Subject Property: 121 Upper Pattagansett Rd. E. Lyme

Plan Designed by: John Paul Mereen, LS Plan Date: **August 3, 2021** Last Revision Date: **12-8-2021***

The plan and associated information submitted to our office on 12-10-2021 for a proposed **8** lot subdivision/commission review. Lots range from 1.08ac to 3.58ac and are to be served by **private well water** and **private septic systems**, in the **Town of East Lyme**.

B100a: Application for Building Addition, Change in Use, Accessory Structure, or Lot Line Change
LEDGE LIGHT HEALTH DISTRICT

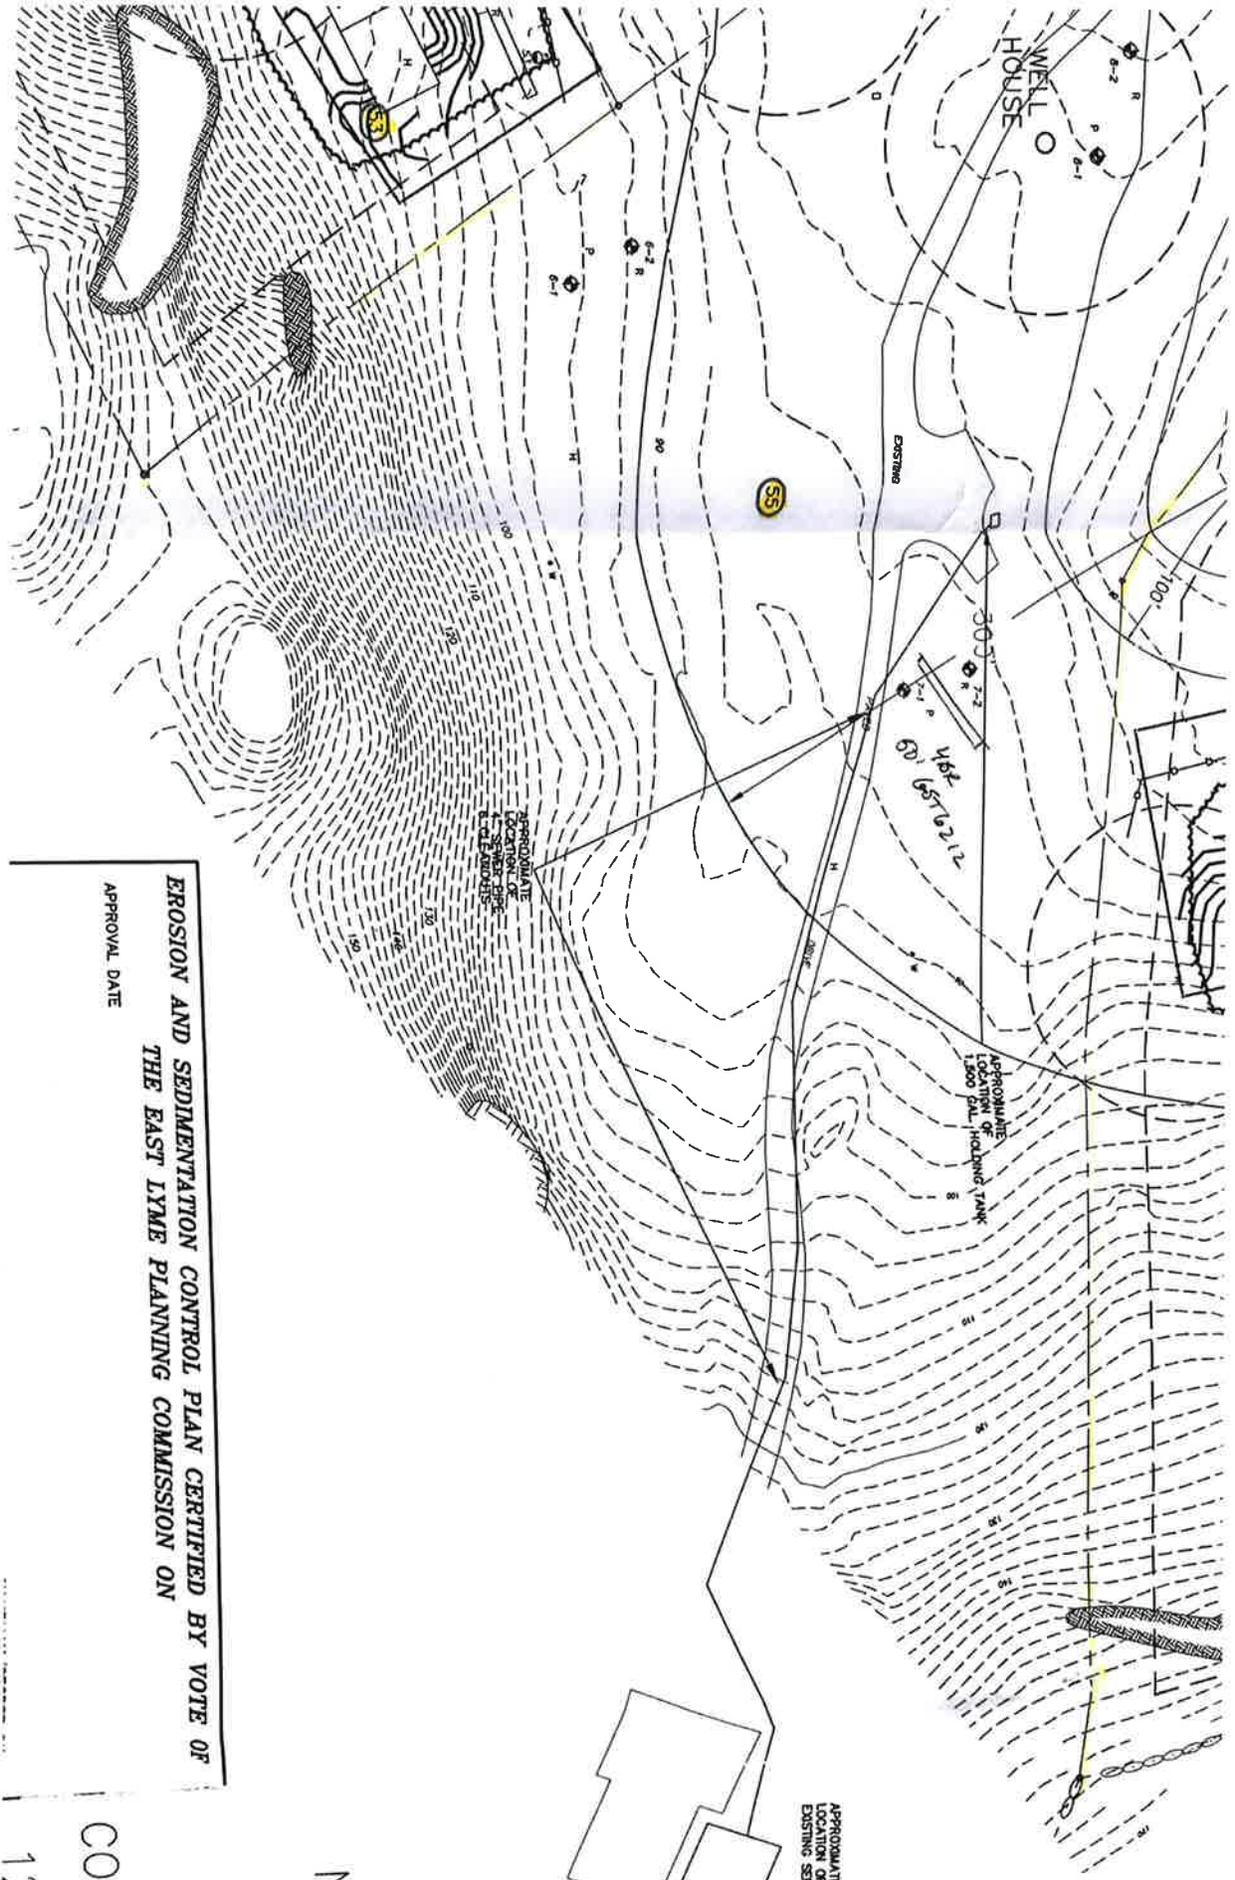
Comments: Based on soil testing, a code complying area exists for a 4 Bedroom dwelling w/An a well. Holding tank shown on site plan requires CT DP4 approval. Lot line approval assumes one ~~the~~ existing building w/4BRs on Lot 55. If other buildings are to remain, additional approvals may be required.
